No heating output during electric driving operation

Topic number	LI83.70-P-080411
Version	1
Function group	83.70 - Auxiliary/supplementary heater
Date	3/30/26
Validity	206,254,214,236
Reason for change

Water heater & coolant hoses illustration before
12/25

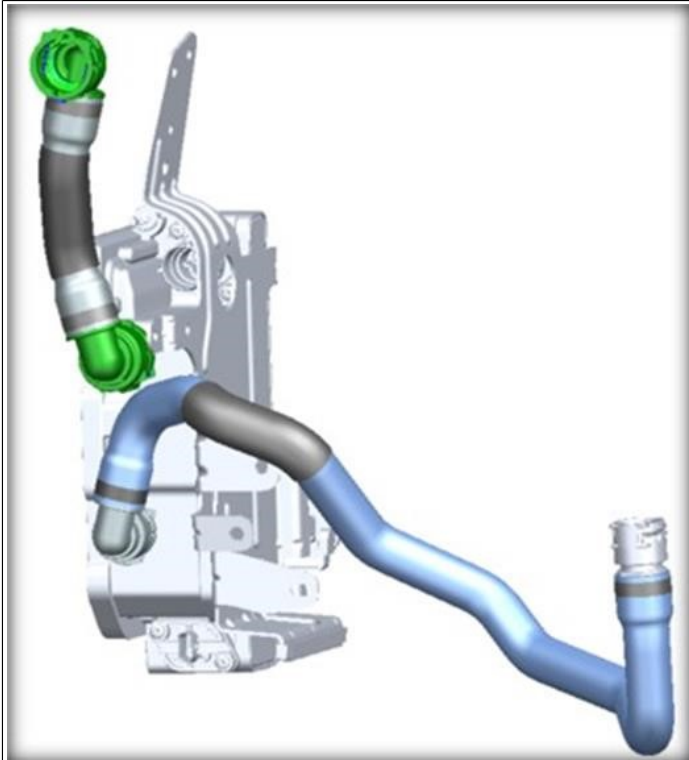
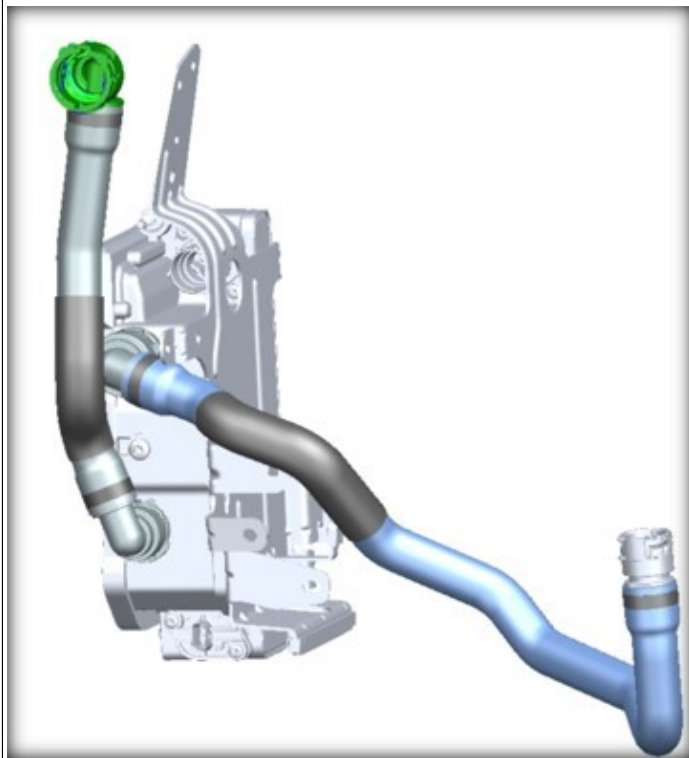
If the N33/5 water heater (PTC booster heater, high voltage) is defective, it must be replaced with the latest part number.

For vehicles manufactured before December 2025 with a BorgWarner water heater, the coolant hoses (inlet and outlet) must also be ordered and installed.

For vehicles produced after December 2025, only the N33/5 water heater (PTC booster heater high voltage) needs to be replaced.
